SECTION 00930
CHANGE ORDER

Change Order No. 1

JD 1 Branch 12 Repair Project

Owner: North Fork Crow River Watershed District
Class of Work: PUBLIC DRAINAGE SYSTEM REPAIR

DROP INLET DETAIL
NOT TO SCALE

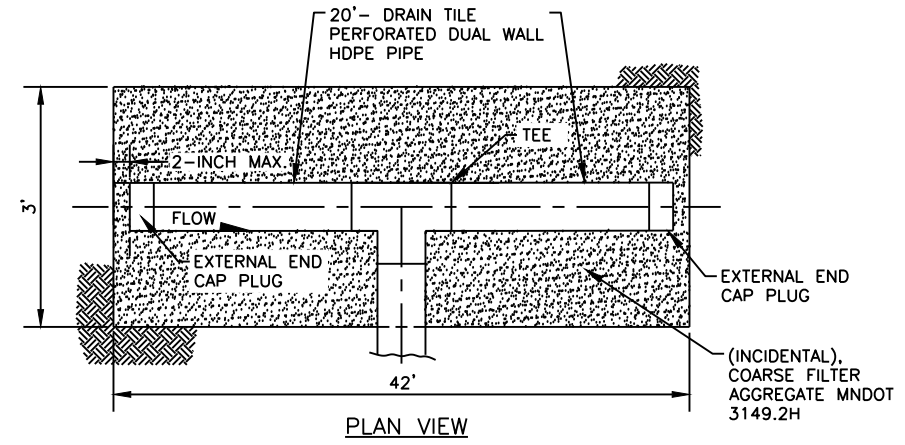
- 1) Items detailed in attached Change Order #1 Cost Summary.
- 2) Drop Inlet and Rock Inlet construction details in the attached drawing.

8	TREE CLEARING >48" DIAMETER. The contractor will complete this work consistent with project specifications for CLEARING and will be paid per tree. Approval must be obtained from Owner or Engineer prior to work being completed.	EACH	4	\$1,000.00	\$4,000.00
9	DROP INLET - 15" Side Inlet Pipe with 12" Hickenbottom Riser (See Detail)	EACH	2	\$2,900.00	\$5,800.00
10	ROCK INLET - 15" Side Inlet Pipe with 40' of 15" Perforated Drain Tile and 30 CY of Coarse Filter Aggregate (see Detail)	EACH	2	\$3,300.00	\$6,600.00
11	ROCK INLET - 15" Side Inlet Pipe with 40' of 18" Perforated Drain Tile and 30 CY of Coarse Filter Aggregate (see Detail)	EACH	2	\$3,580.00	\$7,160.00
12	ROCK INLET - 15" Side Inlet Pipe with 40' of 24" Perforated Drain Tile and 30 CY of Coarse Filter Aggregate (see Detail)	EACH	2	\$3,860.00	\$7,720.00
Total					\$67,670.40

1. THE PERFORATED PIPE INLET AND TEE SHALL BE SIMILAR OR EQUAL TO MATERIALS FROM HICKENBOTTOM TILE.
2. THE PERFORATED SECTION OF THE INLET SHALL HAVE 6 ROWS OF HOLES SPACED AT 2 INCHES, CENTER TO CENTER, AND HAVE A 1 INCH DIAMETER.
3. INLET COMPONENT LENGTHS MAY BE SHORTENED OR LENGTHENED, TO OBTAIN THE REQUIRED HEIGHT OR DEPTH.
